Re: **Lonza Biologics – Proposed Industrial Development  
Site Plan Review & Subdivision Applications**

City of Portsmouth Third Party Review, Altus Engineering, August 6, 2018:			
	Altus Engineering Comment	Applicant Response	Sheet
<b>General Comments:</b>			
1	In general , Altus supports the premise to eliminate the closed drainage system across this property to create an open and vegetated channel. With this modification to the watershed, Altus is concerned that there could be unintended consequences that could impact down gradient properties. The Hodgson Brook watershed is highly developed . The flow through the Lonza site is through a series of pipes which allows the runs to pass through the area rapidly. Opening the channel up slows the flow through the system which will delay and impact the overall watershed time of concentration and the peak rate of runoff during storm events. This could create conflicts with the peak rate of flow elsewhere. Streamworks should document as to how this change will impact the rest of the system.	The following response is from the stream designer Streamworks, PLLC, "In early August, Tighe and Bond received comments regarding concern about down

C-802

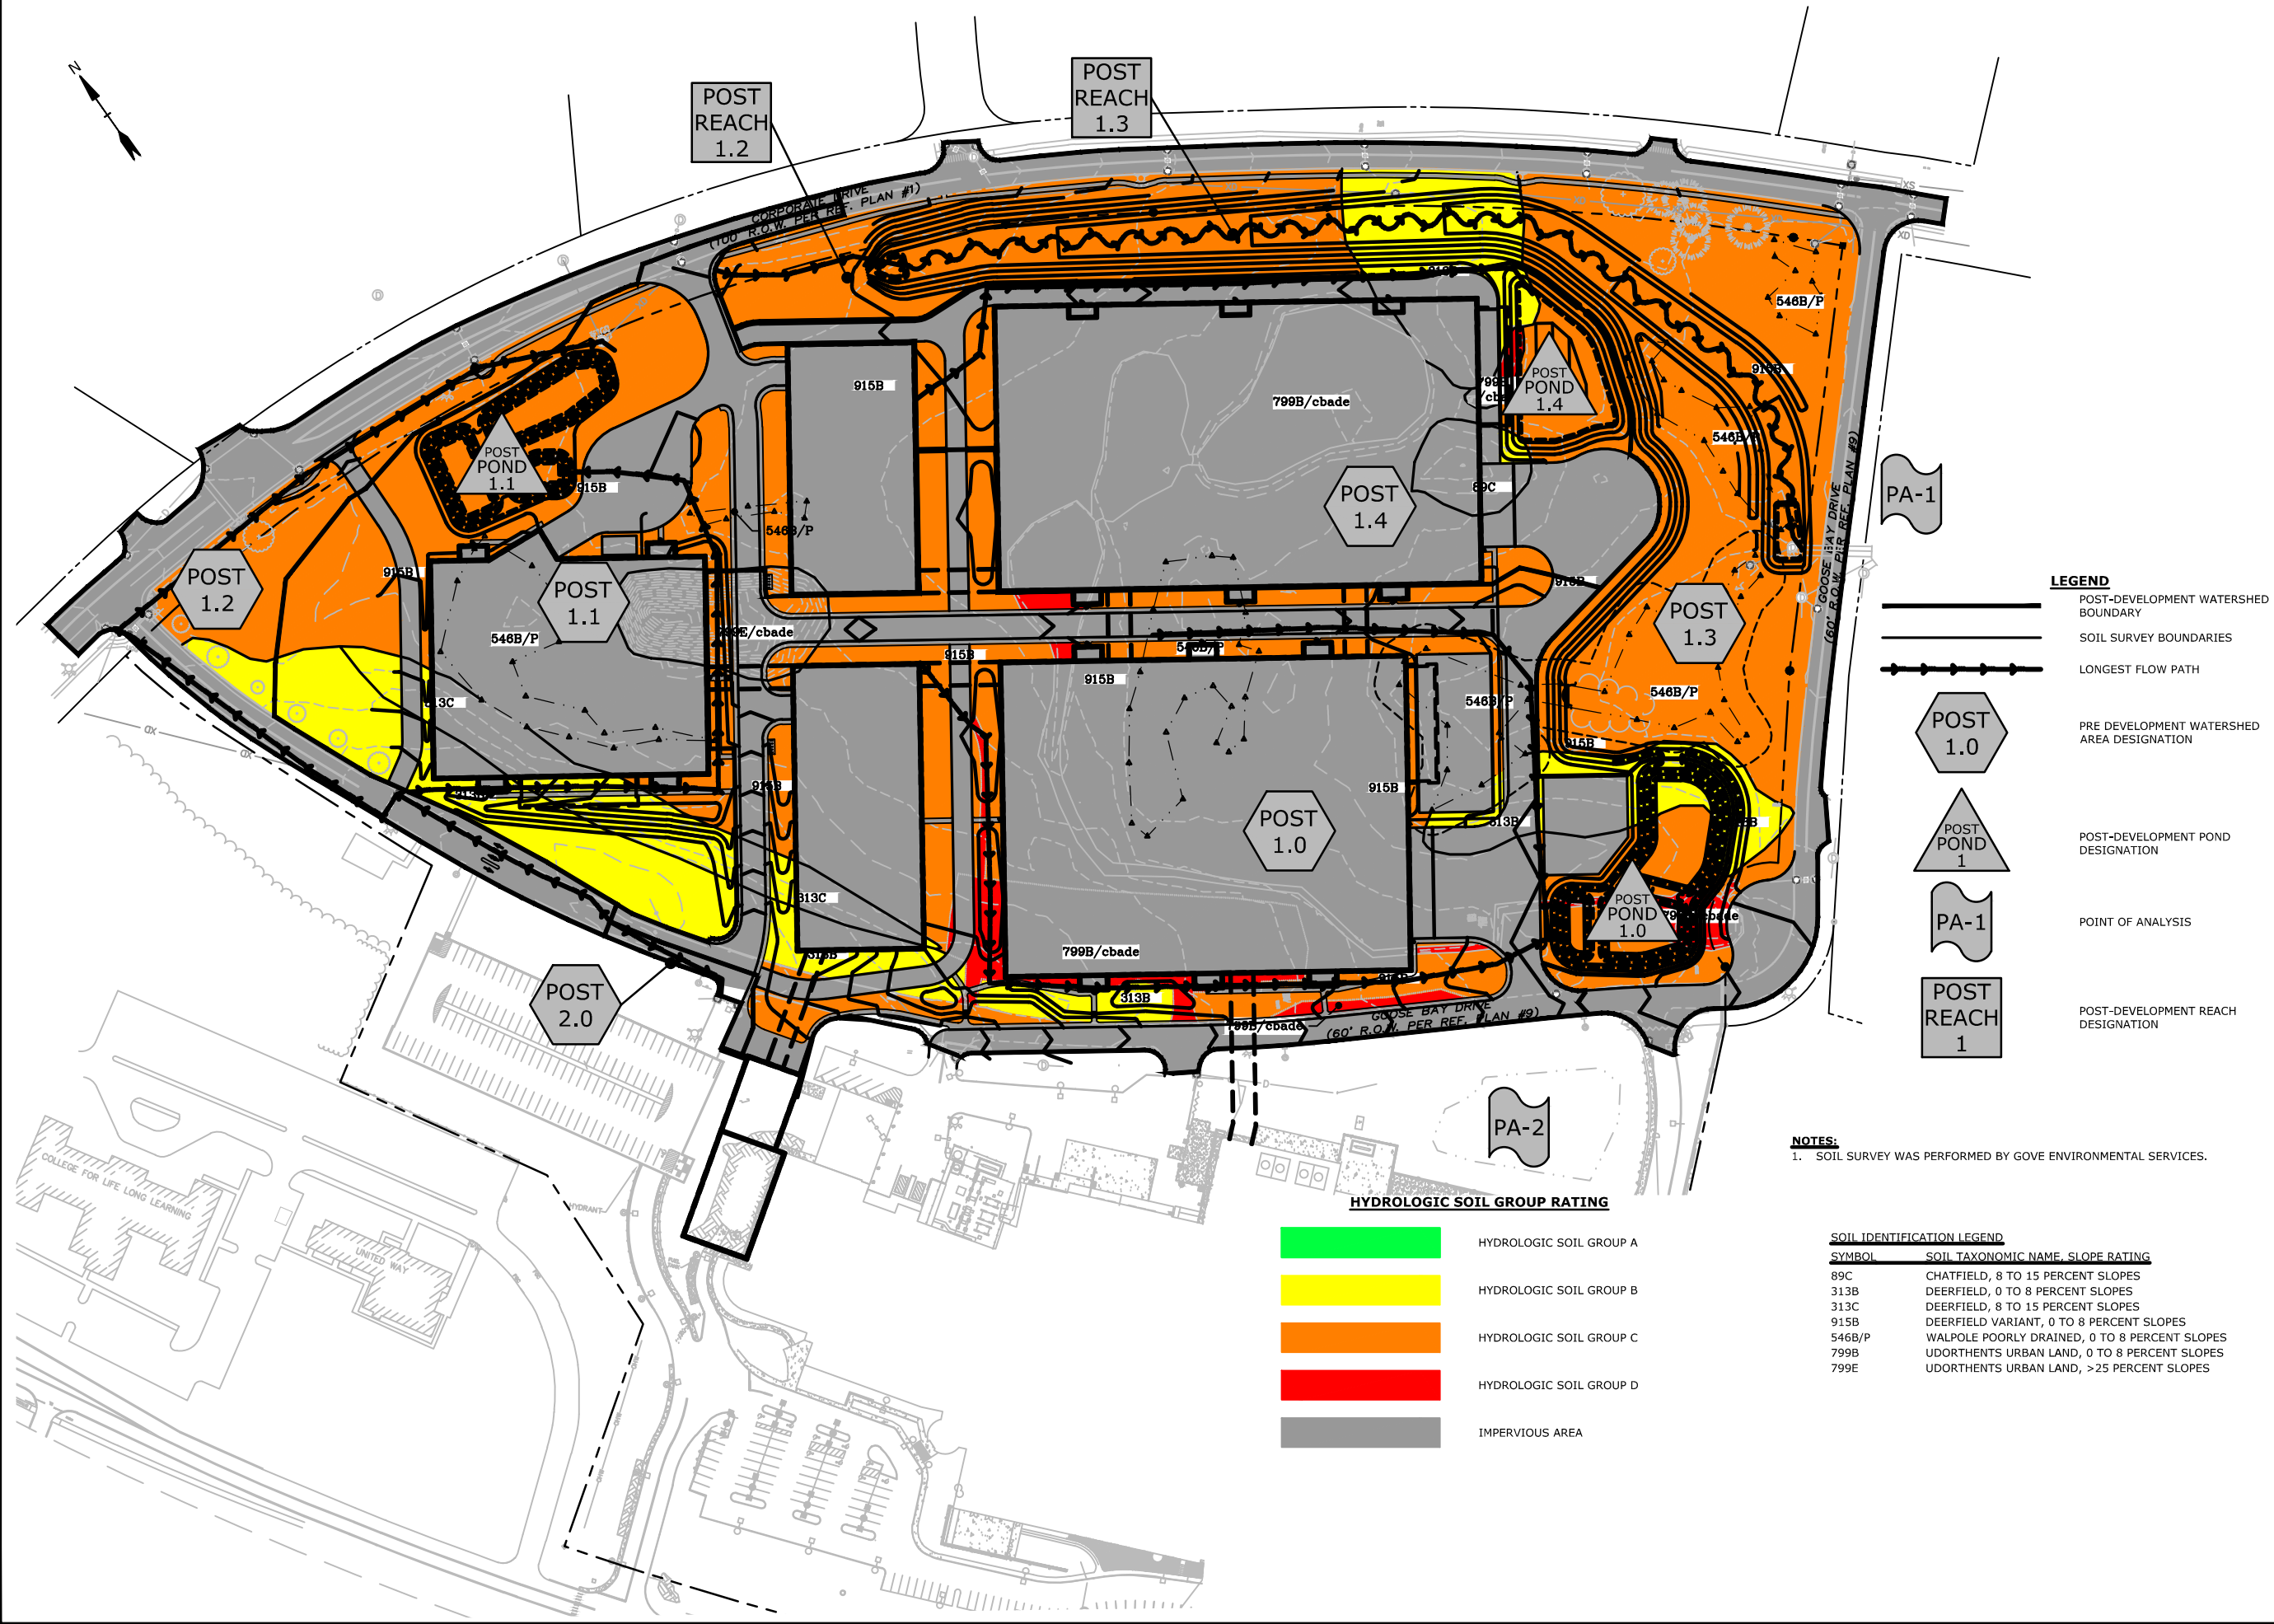
28	Subcatchment Post 1.3 is shown as entering Reach 1.3 (Hodgson Brook) directly, however it will need to pass through the pipe network modeled as Reach 1.2 before it reaches the brook. Please revise.	Subcatchment Post 1.2 (formerly Post 1.3) has been rerouted into Reach 1.2.	N/A

SUBSURFACE EXPLORATION  
PLAN

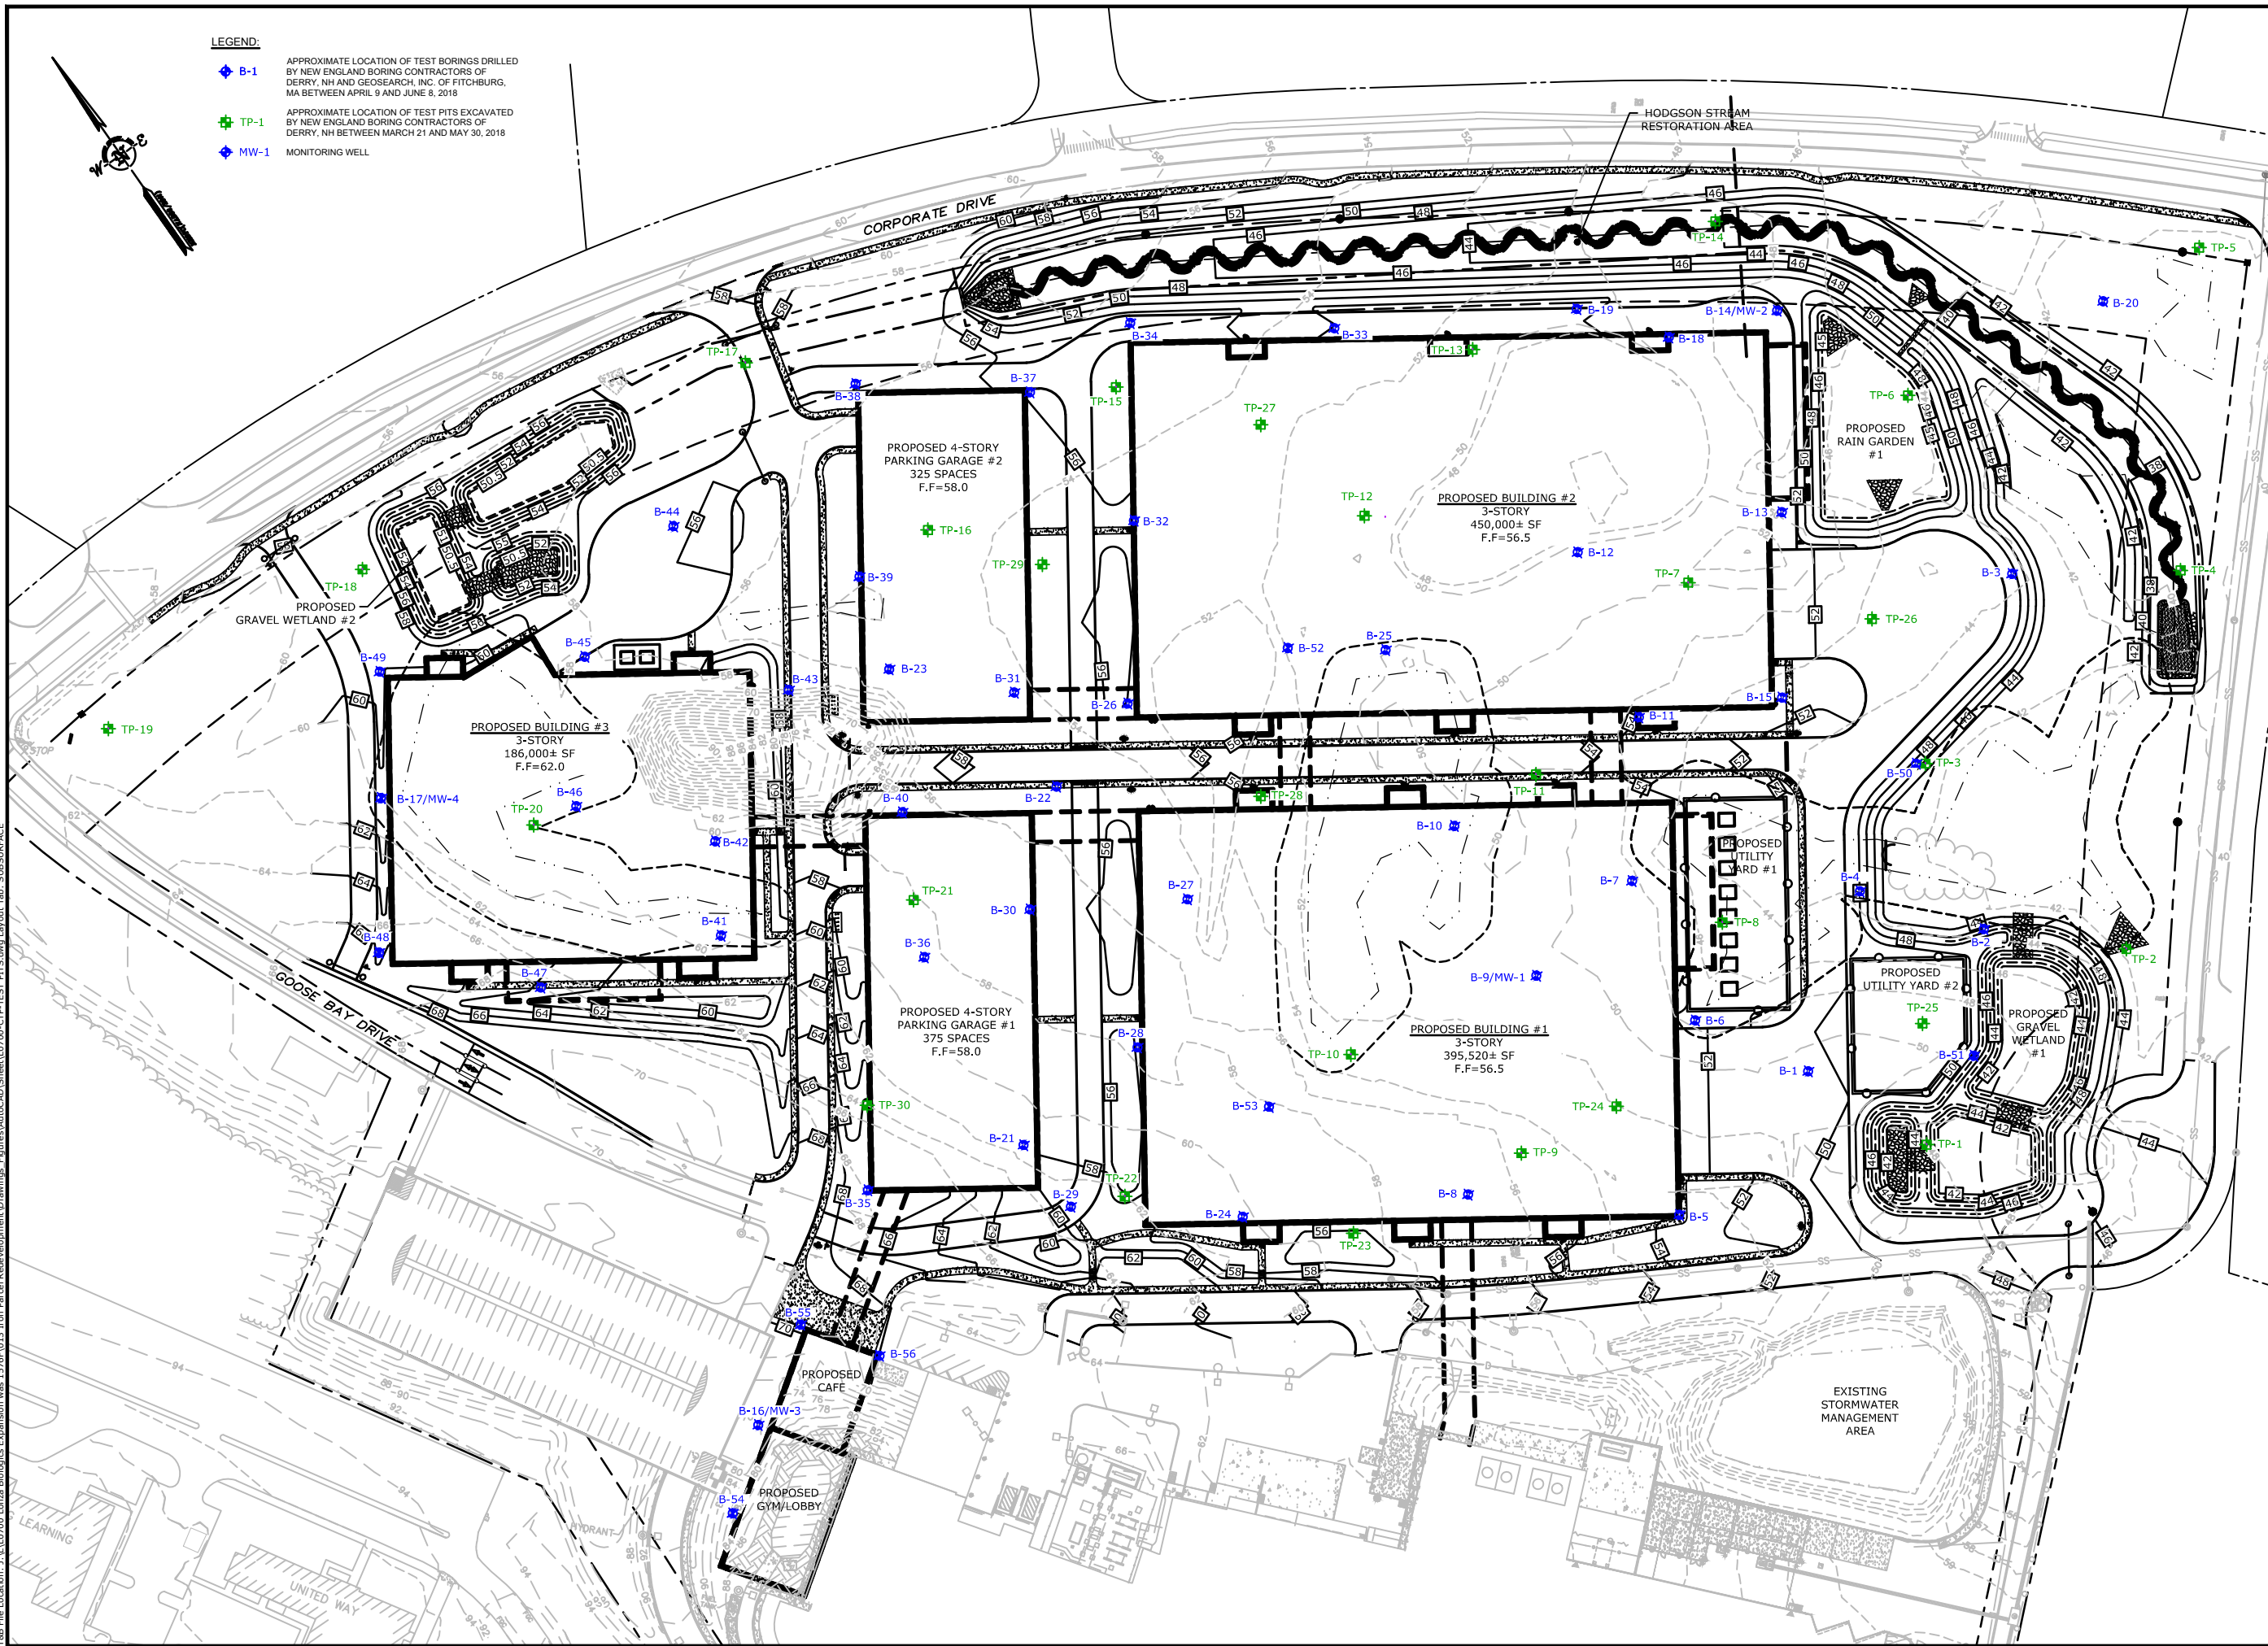
<b>Appendix B, Soil Report and Boring Logs</b>			
35	Provide boring logs for the test pits in the vicinity of the proposed gravel wetlands so as to verify the assumed seasonal high water shown in the BMP worksheets (TP-1, 2, 17 and 18).	Boring logs for the test pits in the vicinity of the proposed gravel wetlands and raingardens (TP-1, 2, 17 and 18) have been provided.	N/A
